INSPECTION REPORT

LARCHMONT ESTATES SUBDIVISION

SAVANNAH, GEORGIA

U.S. ENVIRONMENTAL PROTECTION AGENCY

APENDIX A
PHOTOGRAPHIC LOG

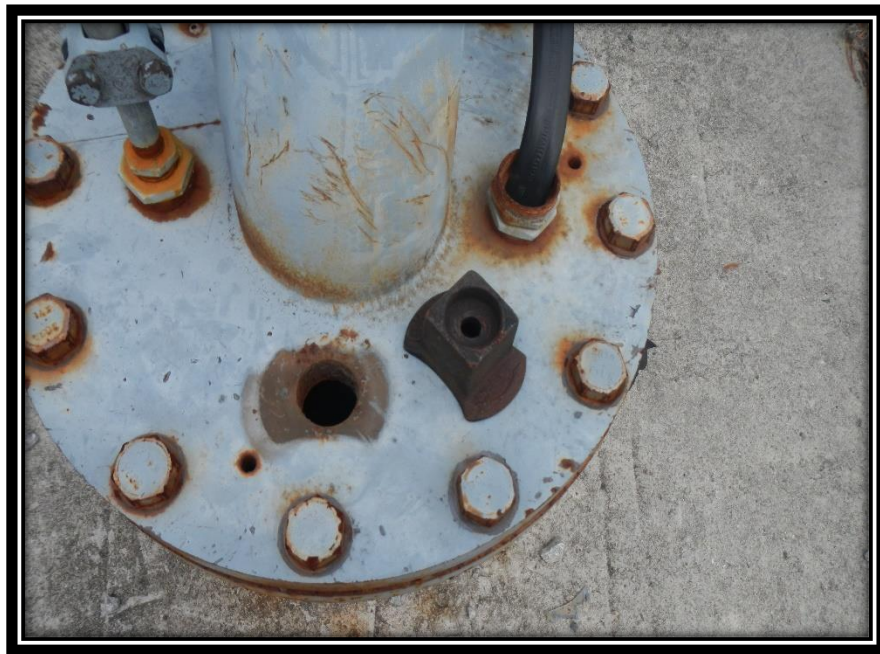
6. **Findings:** In Well Number 109 the EPA inspector observed openings in the casing of the well pump and in the well the pad. (Refer to Appendix A, Image 1 & 2)

9. **Findings:** The EPA inspection team observed threaded samplings taps in the following wells: Well 109, Well 106, Well 104, Well 5, Well 8, Well 10, Well 2, Well 3, Well 101. (Refer to Appendix A, Image 3)

Observation: The EPA inspection team observed air vents without 24-mesh in the following locations: Well 109, Well 106, Well 104, Well 5, Well 8, Well 10, Well 2, Well 3, Well 101, Elevated storage tank and all Hydropneumatic Tank. (Refer to Appendix A, Photographs 4-6)

Comments: Pursuant to 40 C.F.R. § 141.723 (Requirements to respond to significant deficiencies identified in sanitary surveys performed by EPA). *“A significant deficiency includes a defect in design, operation, or maintenance, or a failure or malfunction of the sources, treatment, storage, or distribution system that EPA determines to be causing, or has the potential for causing the introduction of contamination into the water delivered to consumers”*. Unprotected access points to the water source provide a pathway for contaminants to enter the water source and pose a risk to public health. The system must seal the openings.

Comments: Pursuant to Georgia Rules For Safe Drinking Water 391-3-5-.13. Cross Connections “No person shall construct, maintain or operate a physical arrangement whereby a public water system is or may be connected directly or indirectly with a non-potable water system or non-permitted water system, sewer, drain, conduit, pool, storage reservoir, plumbing fixture, or other device which contains or may contain contaminated water, liquid, gasses, sewage or other waste of unknown or unsafe quality, which may be capable of imparting contamination to the public water system as the results of backflow, bypass arrangements, jumper connections, removable sections, swivel or changeover devices, or other temporary, permanent or potential connections through which or because of which back-flow or back-siphonage could or would occur”. The System must install a back-flow protection device or remove the threading from the taps.

Comments: Air vents & overflows must be screened with 24- mesh to prevent the entry of contaminants.
